Subject: Duke Energy Carolinas, LLC
Oconee Nuclear Station (ONS), Units 1, 2 and 3
Renewed Facility Operating License Numbers DPR-38, -47, -55;
Docket Numbers 50-269, 50-270 and 50-287;
Duke Energy's Recommended Revisions to the Oconee Nuclear Station Section of
NRC's Screening Analysis Report for the Proposed Generic Issue on Flooding of Nuclear
Plant Sites Following Upstream Dam Failure

**Duke Energy's Proposed Revisions to ONS Section of NRC's Screening Analysis Report
for the Proposed Generic Issue on Flooding of Nuclear Plant Sites Following Upstream
Dam Failure**

Figure 1: Location of Keowee and Jocassee Dams Relative to Oconee Nuclear Station

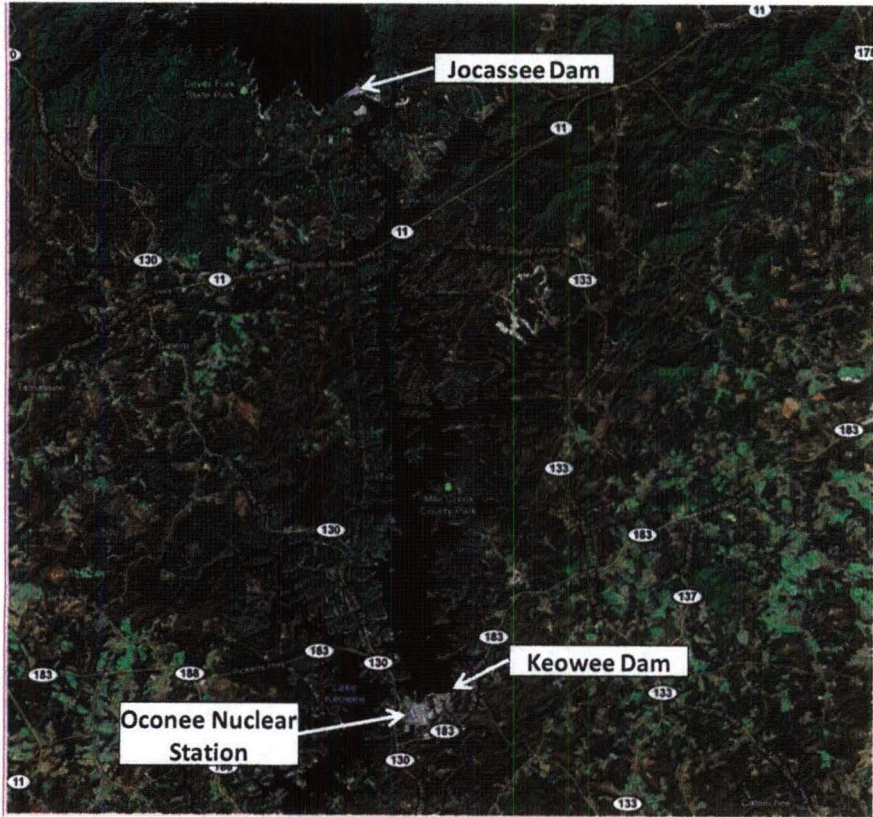
Comment [r3]: Redact: Labeled Figure should be redacted. While image is publicly available, relationship of Jocassee Dam location relative to Oconee Nuclear Station is not typically annotated in public information.
